RE: Stone Creek Village (DD10072)

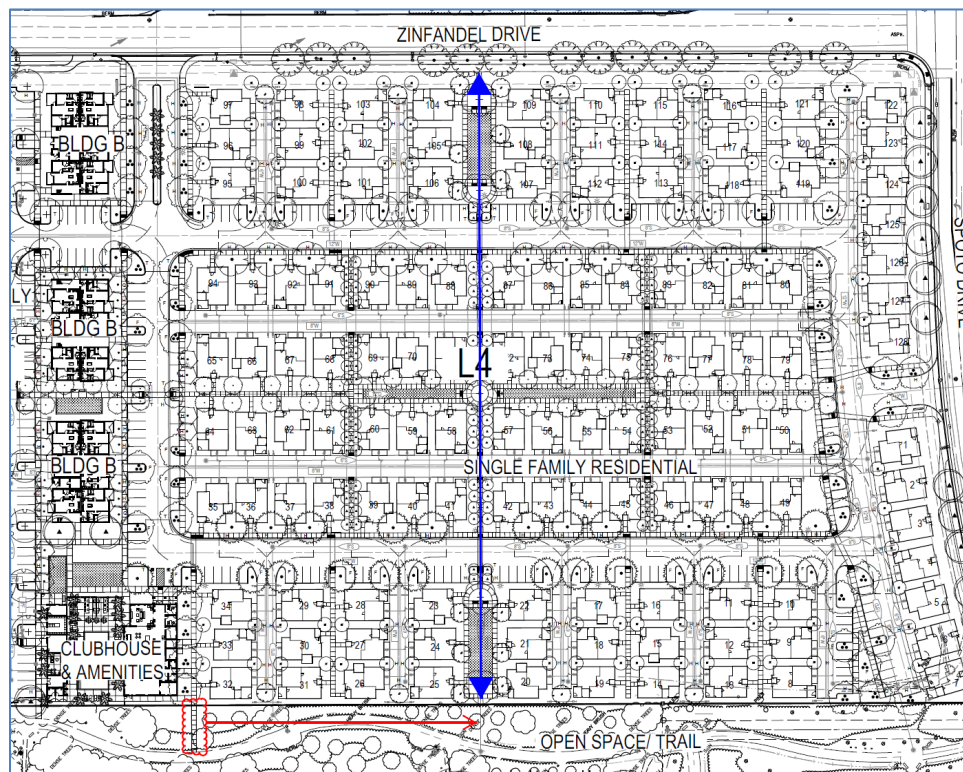
First, there's no direct pedestrian route between the southernmost apartment building (we have labeled it BLDG 1 in the figure below) and the grocery store (Major 1). The walking route (marked with a solid orange line in the figure) from the middle entrance of Building 1 to the Clubhouse, past Buildings 5 and 2, and then to the closest end of the east-west sidewalk on Lot 3 (Major 1) is over 800 feet with several out-of-direction segments. A route using the landscape planter between the multifamily parking and the back of the retail parking (dashed orange line) would reduce the walking distance to about 350 feet.

Adding this section of sidewalk would make it much more convenient for residents of Building 1 to walk to the store, but it would also make it more convenient for residents of the homes in the southwest corner of the Veranda (single-family) area. For many other Veranda residents, the walking distance using this recommended second route may be about the same as the proposed walking path, but the second route would provide an alternative that could encourage more walk trips because pedestrians generally prefer to have route choices for trips they frequently make.

It appears that trees in the landscape planter between the retail lot and the multifamily lot may need to be relocated to make room for a sidewalk. While the multifamily area is parked at only one space above the required number, the retail area has 84 more spaces than required. We suggest that some of the parking spaces at the rear of Major 1 be used for additional tree planters to accommodate relocated trees, if needed.

We recommend adding a sidewalk between BLDG 1 and Major 1 as illustrated above with the dashed line.

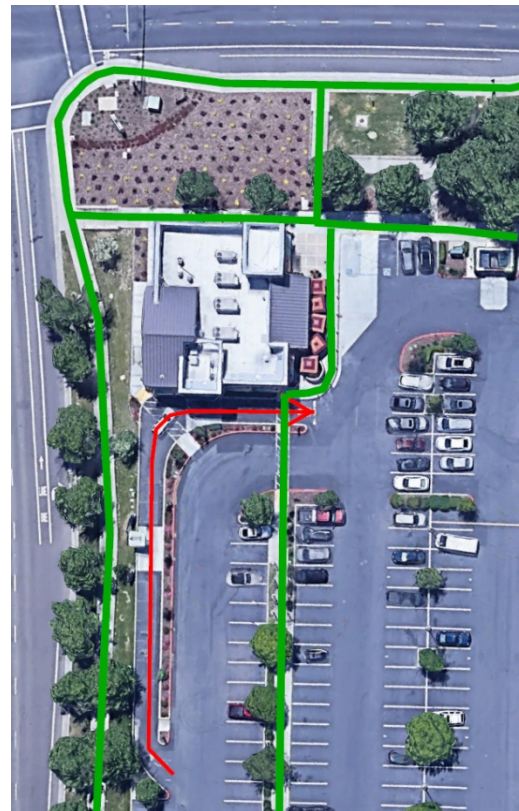
Second, the single family houses on lots 8-34 along the southern edge of the site and lots 95-121 along the northern edge of the site don't have a sidewalk connecting the pedestrian paseos serving each group of six alley-loaded units. This can require several driveway crossings to walk between homes. The figure below shows the missing sidewalk segments as dashed orange lines. We recommend adding sidewalks along the north side of lots 11, 16, 17, 22, 23, 28, 29, and 34 and along the south side of lots 95, 100, 101, 106, 107, 112, 123, and 118.
